## Service Note 01175171

Budapest, January 2024

We regret to inform you about a potential issue that may affect the performance of Simcenter T3ster SI LP220 modules in certain usage scenarios. It has come to our attention that the 20mA and 200mA current ranges of these modules may be susceptible to internal degradation under specific conditions.

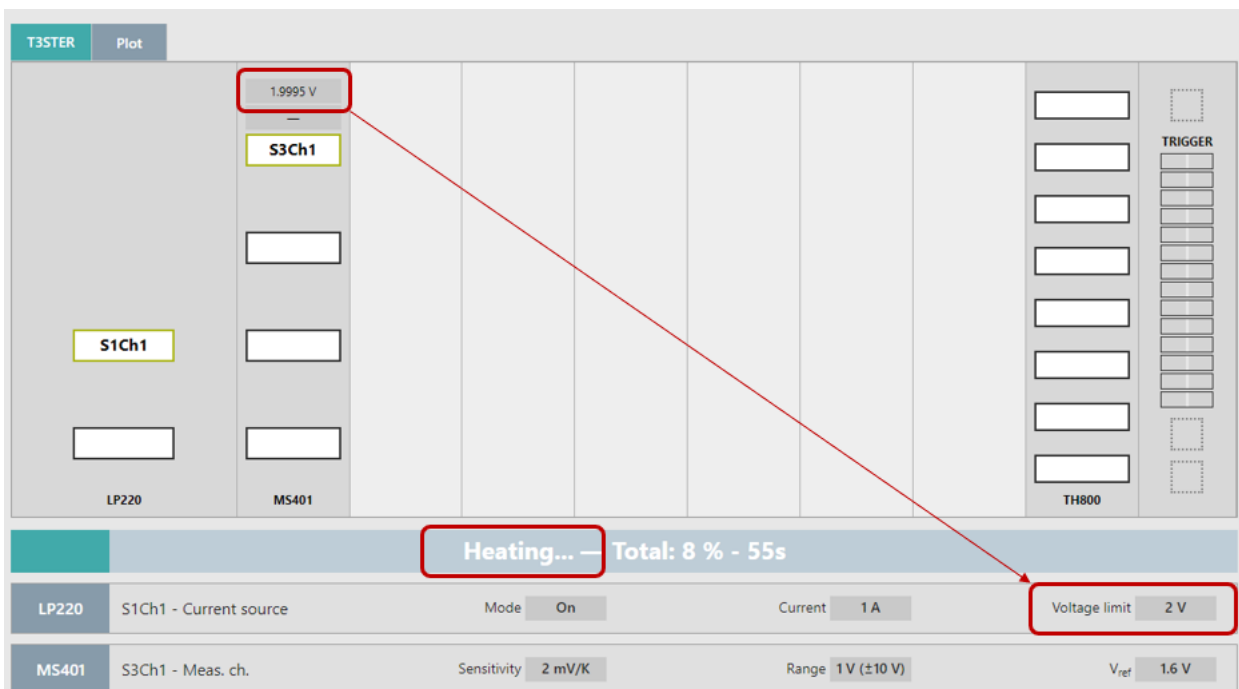
All Simcenter T3ster SI LP220 modules, specifically, the 20mA and 200mA current ranges.

The identified concern arises when a current pulse occurs in the internal analog circuit of the current generator surpassing the safe operating range of certain components. Repeated exposure to these pulses may lead to degraded performance and, ultimately, the failure of the component or circuit.

This pulse occurs during the transition of the current generator from voltage-limited mode to current source operation, which can happen under the following conditions:

- Avoid changing the Device Under Test (DUT) wiring while the T3ster SI output is active. This includes both manual modifications and multiplexer switching.
- Refrain from activating an LP220 heating current output with no load connected (open circuit condition).
- Ensure that the LP220 current generator voltage limit is set high enough to remain above the load voltage, even during the heating phase.
